Dresden Nuclear Power Station, Unit 2  
Facility Operating License No. DPR-19  
NRC Docket No. 50-237

Subject: Additional Information Supporting the Request for Technical Specifications Change for Minimum Critical Power Ratio Safety Limit

**Attachment C**  
**Additional Information Supporting the Request for Technical Specifications Change**  
**for Minimum Critical Power Ratio Safety Limit (Non-Proprietary)**  
**Dresden Nuclear Power Station, Unit 2**

Figure 2

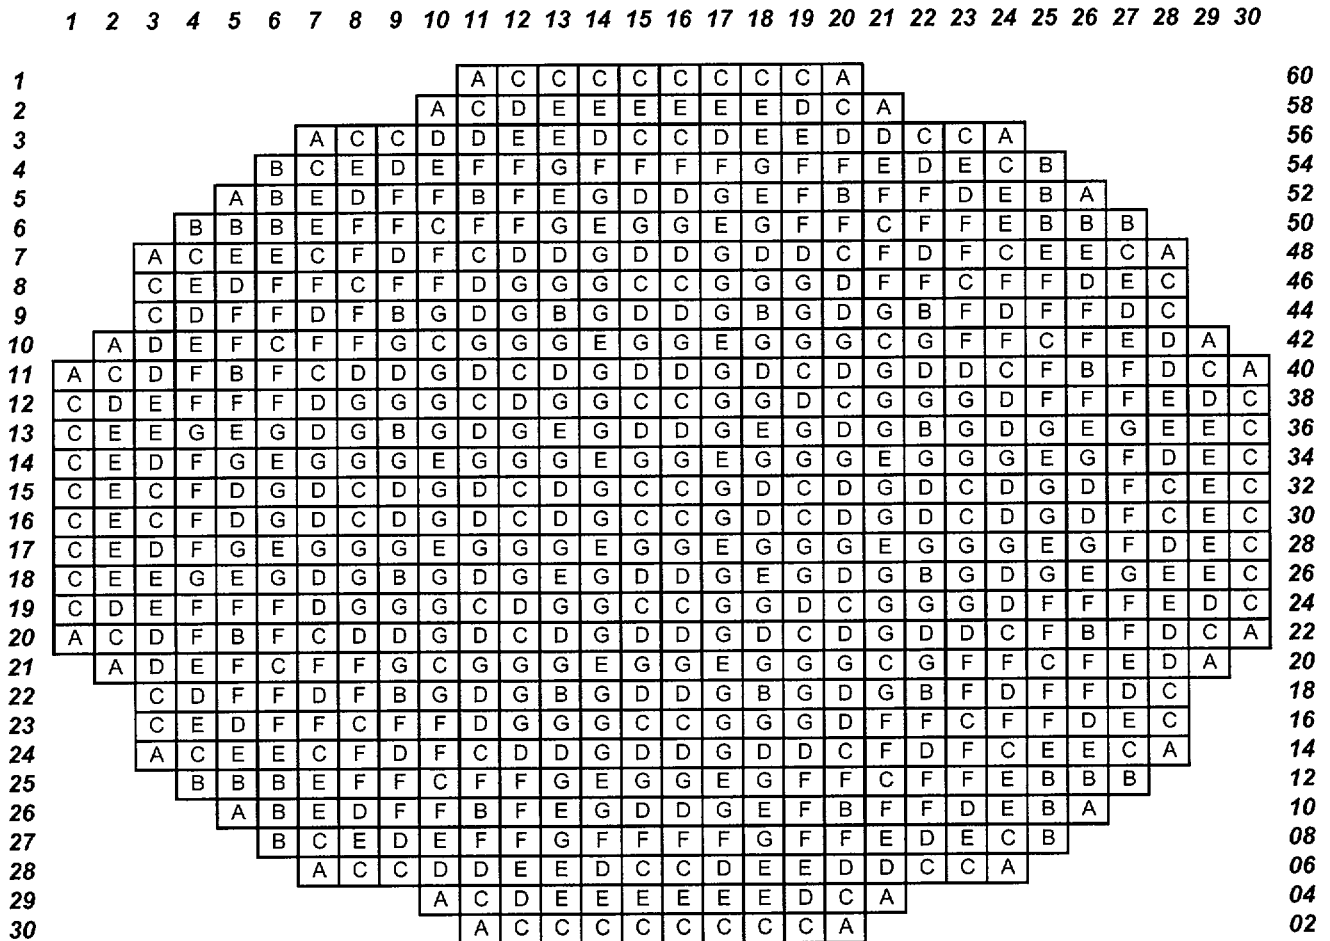
*Provide the fuel types and numbers of assemblies used in Dresden Cycle 17 and Cycle 18 operation and identify if they are fresh or irradiated fuel (once or twice burned, etc.). Also, describe the impact on the Safety Limit for the Minimum Critical Power Ratio (SLMCPR) calculation based on the fuel loading patterns for Cycle 17 and Cycle 18 mixed core.*

The fuel types, number of assemblies, cycles burned, and identification of cycle loaded are included as Figures 1 and 2 for Dresden Nuclear Power Station (DNPS), Unit 2, Cycles 17 and 18 (D2C17 and D2C18), respectively. The two loading patterns are identical to those provided in Attachment F of Reference 1. The legend is expanded to add the number of cycles burned and the cycle loaded.

In Figure 2 (D2C18), fuel type A is the FANP two water rod 9x9 design (28 assemblies total, which are all located on the core periphery). Fuel types B, C, D, and E are the FANP ATRIUM 9B design (416 assemblies total), while fuel types F and G are the new General Electric (GE) Company GE14 assemblies to be loaded (280 assemblies total).
